Re: #14ITB93431K-MH
Renovation and Expansion at the Auburn Avenue Research Library

ADDENDUM NO. 1

AUBURN AVENUE RESEARCH LIBRARY

EXPANSION AND MANOR RENOVATIONS

HANDRAIL DETAIL

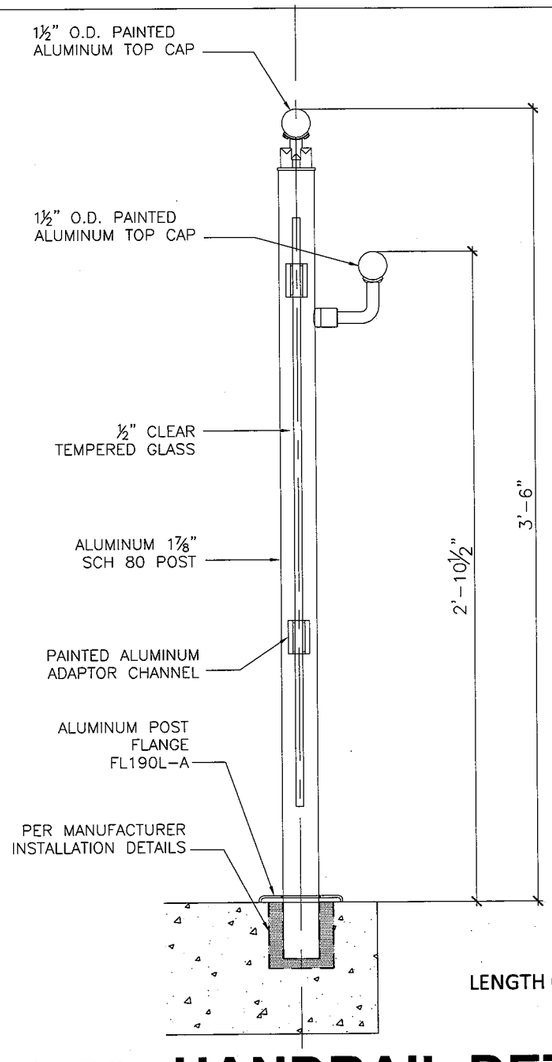
Answer: The slate for this sill shall match the existing slate sills.
3	**Question:** Section 41A252indicates a glass handrail. The glass handrail is not indicated on the floor plans. Please provide dimensions, details and specifications.

Answer: Provide in this Addendum No. One. See attached SD drawing.
4	**Question:** Please verify if S00213 wall panels per A-011 61A-251, A/A-253 and 5/A-253 are specifications 657500 decorative formed metal.

SD-111

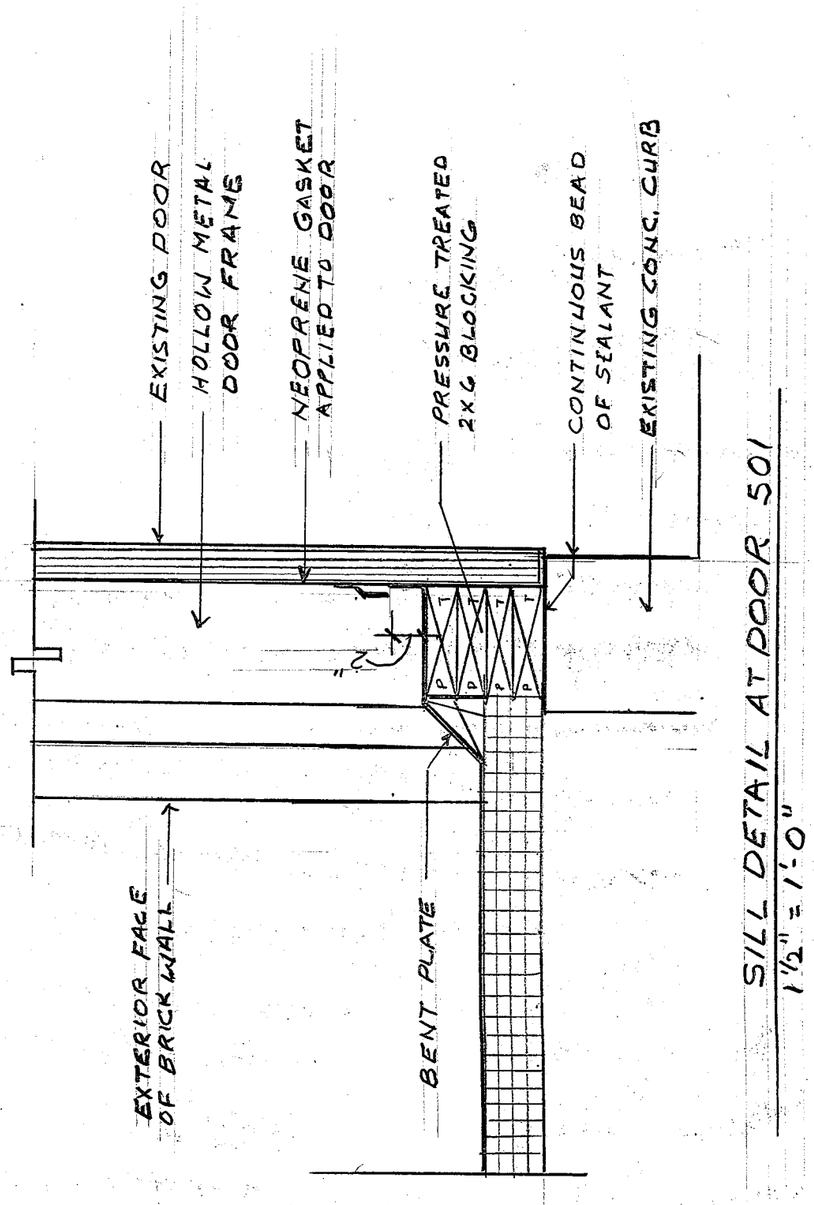
Answer: Contractor to install A 1/16" metal plate on both sides to close opening.	
8/22/2014	A-101	In mechanical room, mezzanine level - need to add a guard rail along the south edge of elevated platform.

Answer: Contractor to provide pipe guard rail at the south edge of the mechanical room elevated platform to match the pipe rail at the north edge of the elevated platform. See SD-111 this Addendum.	
8/22/2014	A-101	Please add note by door C101.1 - Repair crack in concrete slab.

SHEET NUMBER
A-101-D

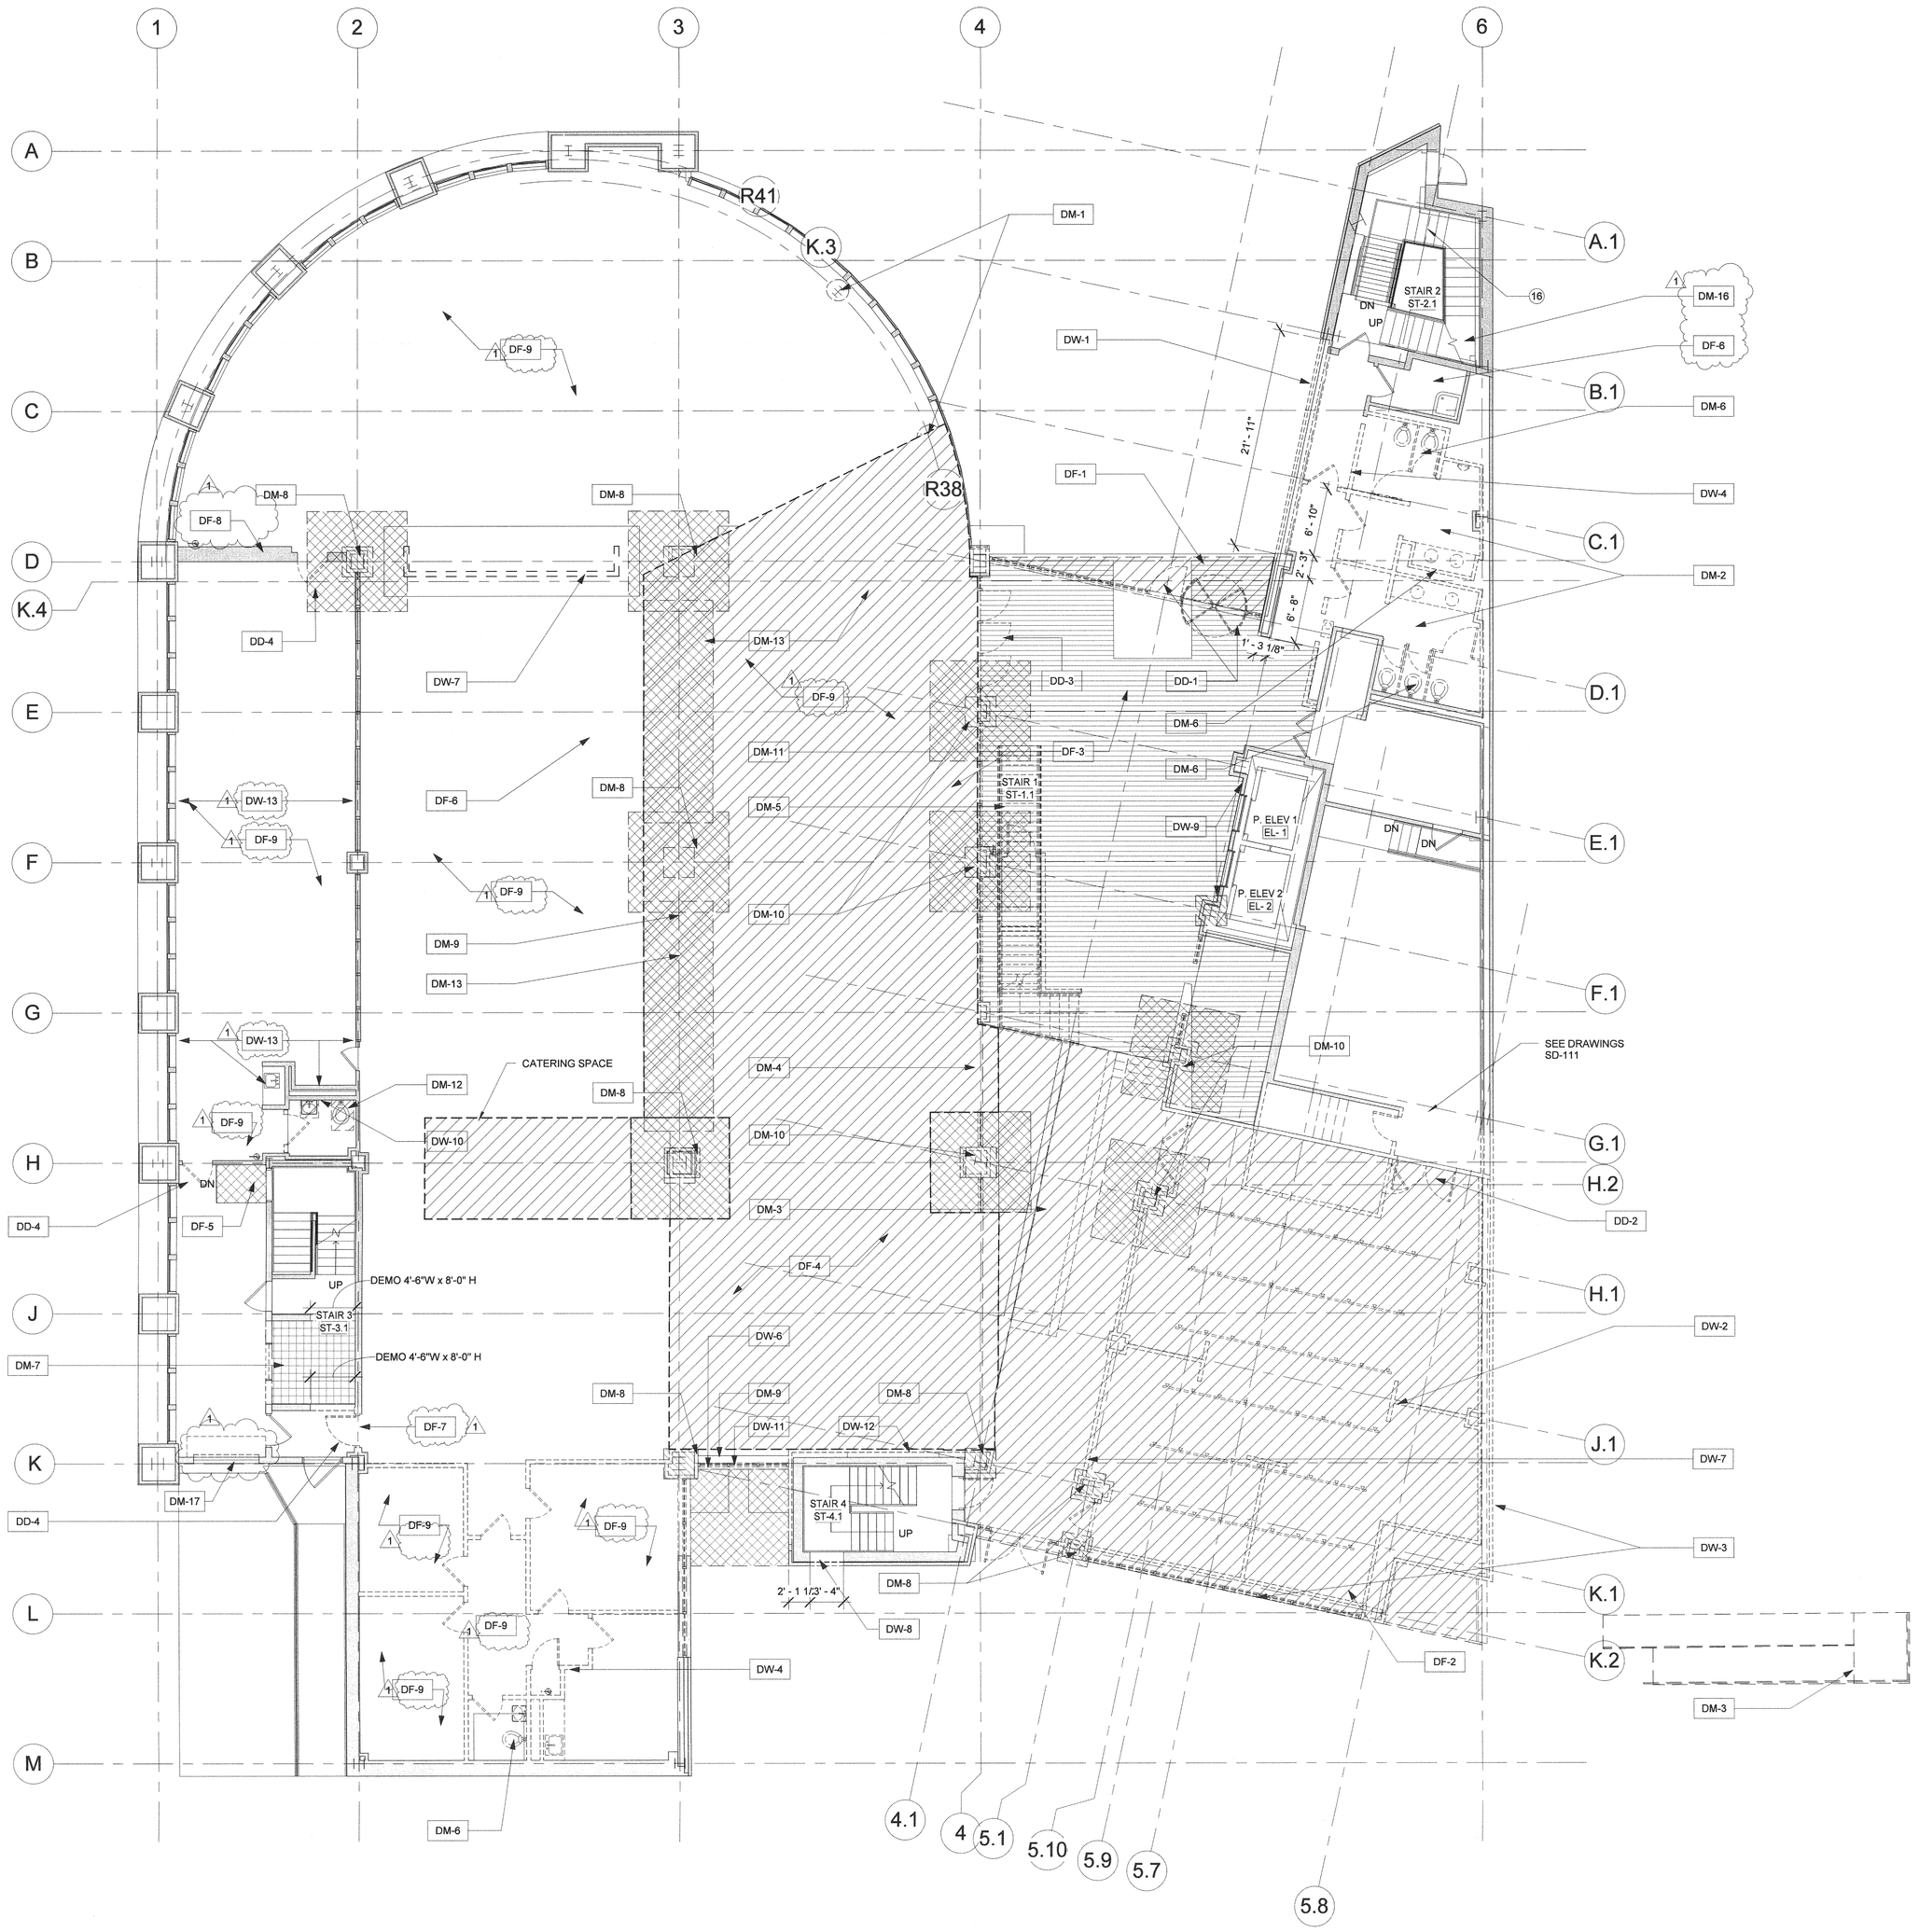
Answer: The Contractor to repair crack in the concrete floor slab noted on A101-D	
8/22/2014	A-101 & A-311	The CMU at both sides of the loading dock door needs to be replaced. Door 109.2 and loading dock wall protection will need to be removed and re-installed.

Answer: See A101-D this Addendum.

SHEET NUMBER
A-103-D

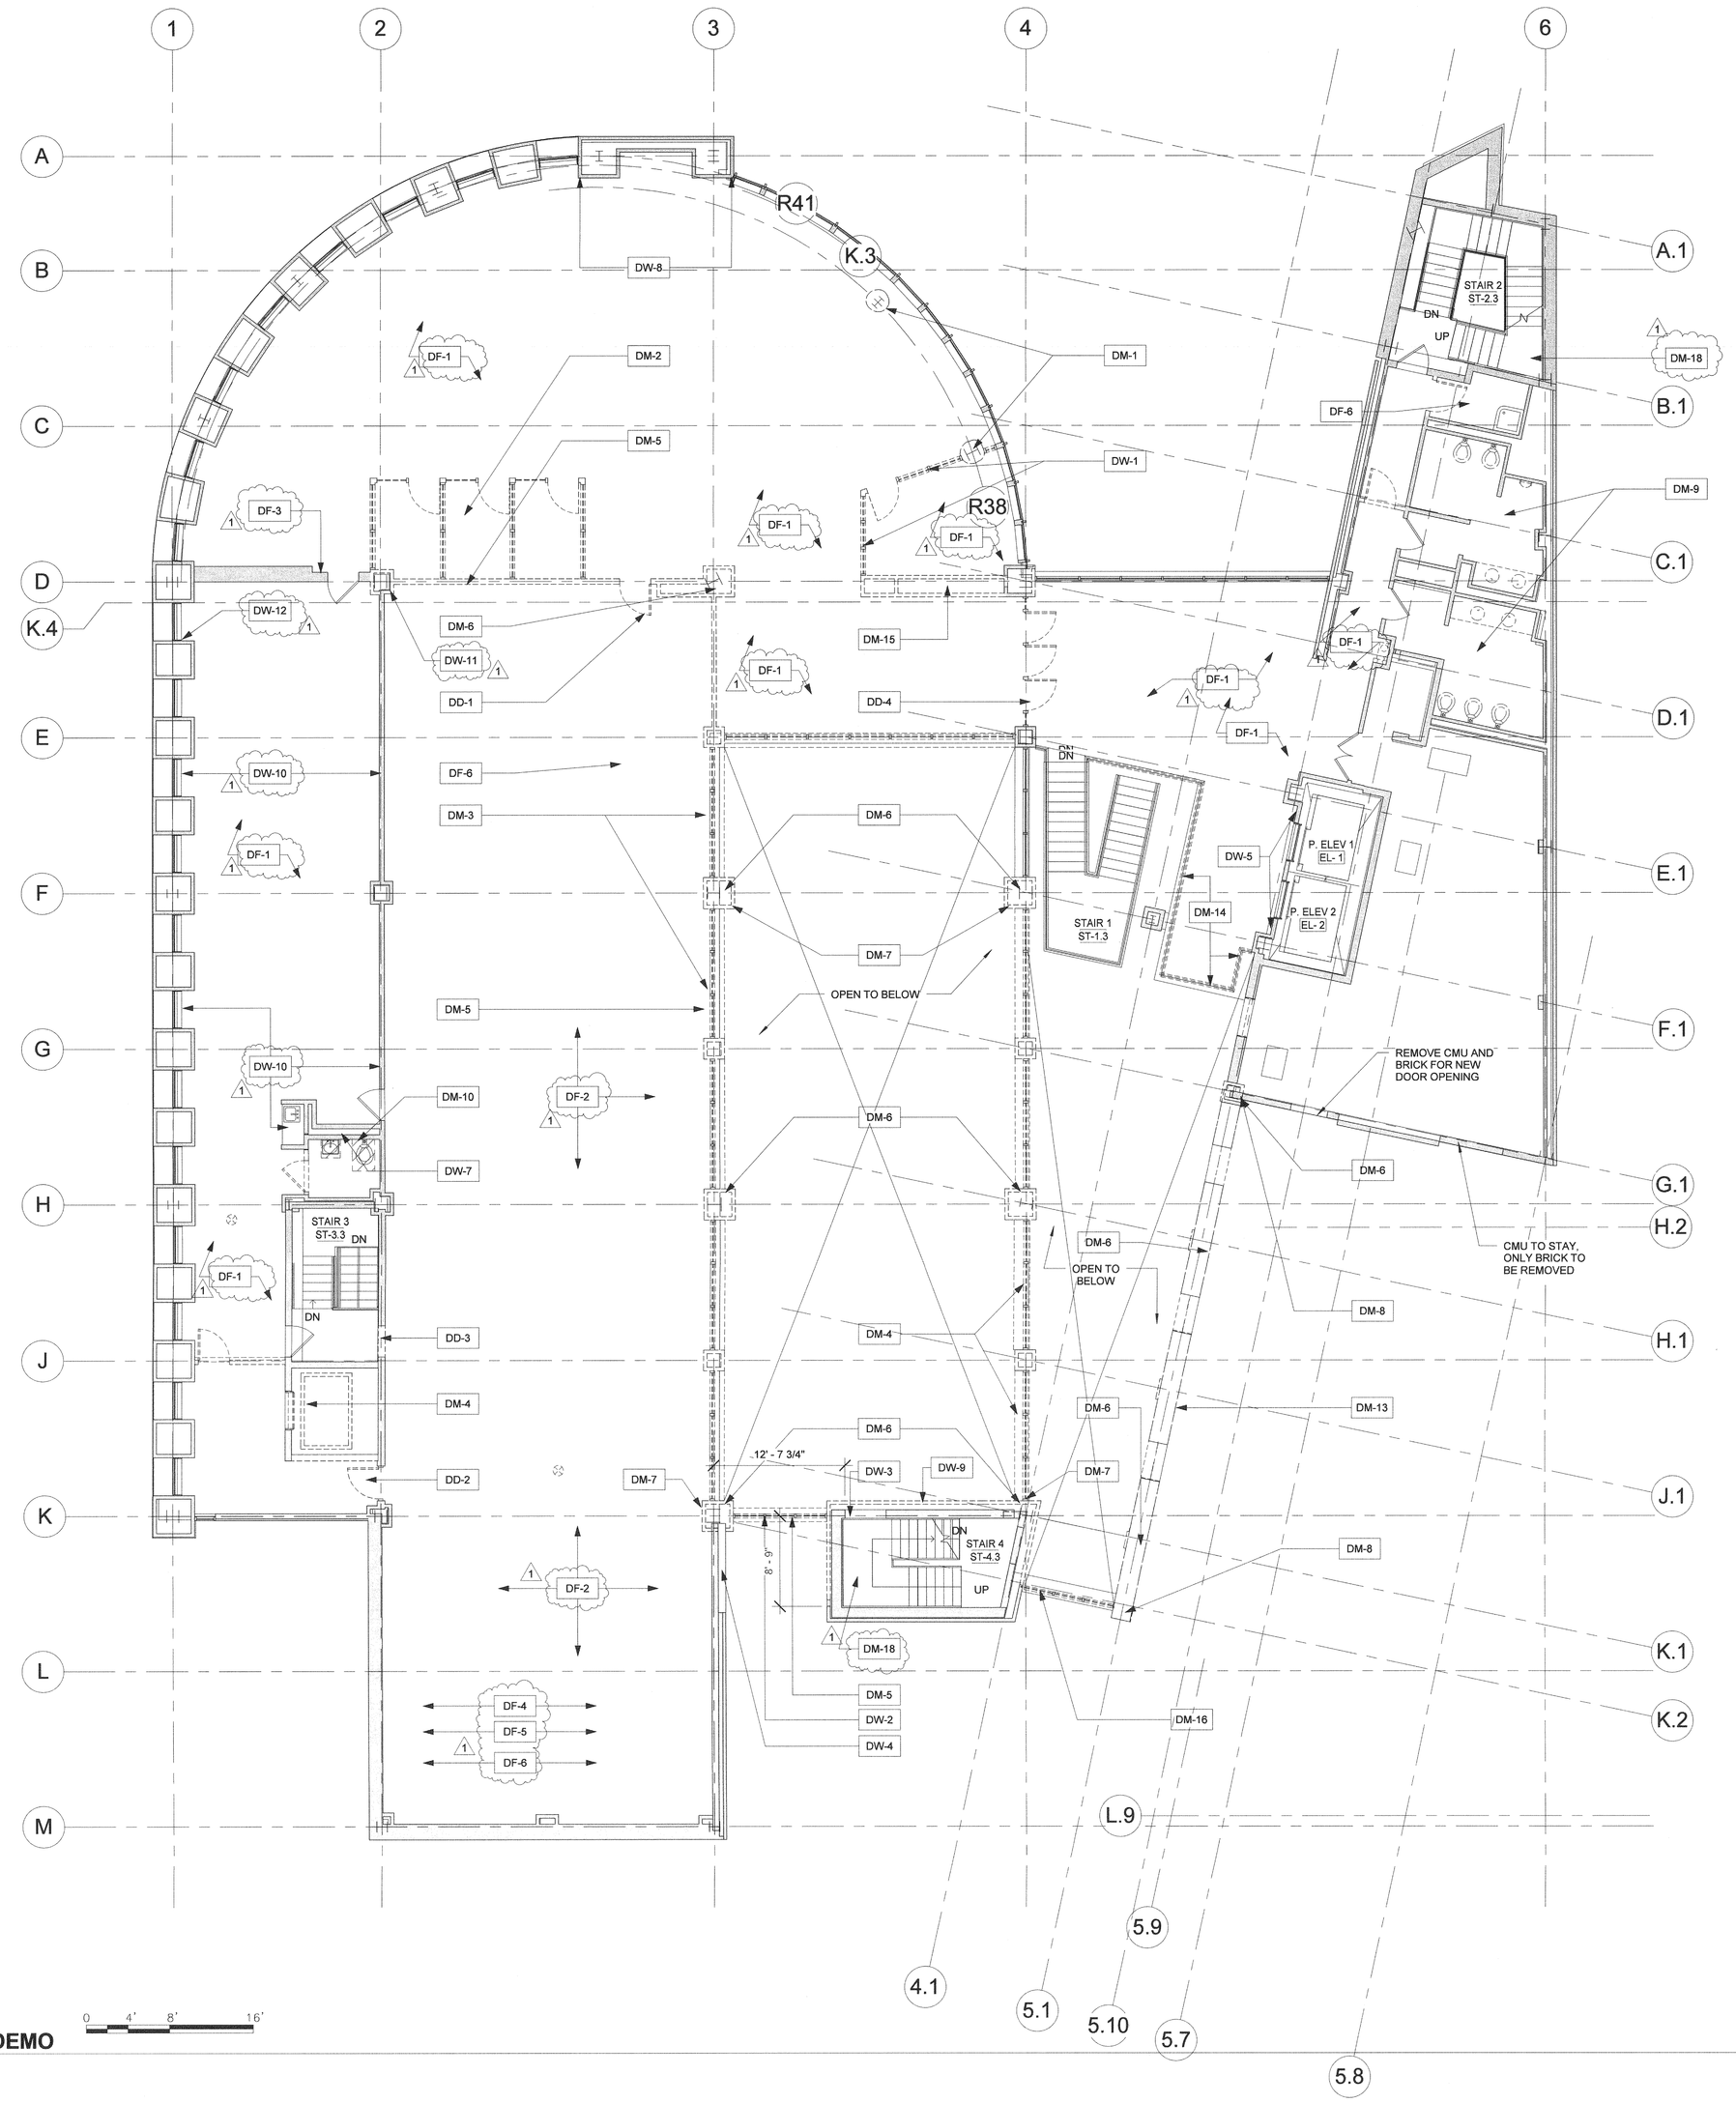
Answer: Contractor to remove existing wall covering in rooms 107, 203, 303, and 304 and prep walls for future painting.	
9/9/2014	A-103-D	Add note to remove 1x4 and shelving anchors in wall. Patch and paint.

Answer: See A-103-D this Addendum	
9/9/2014	T-001	Add "PP" symbol and description to Security System Legend	
		Answer: See TLC drawing this Addendum
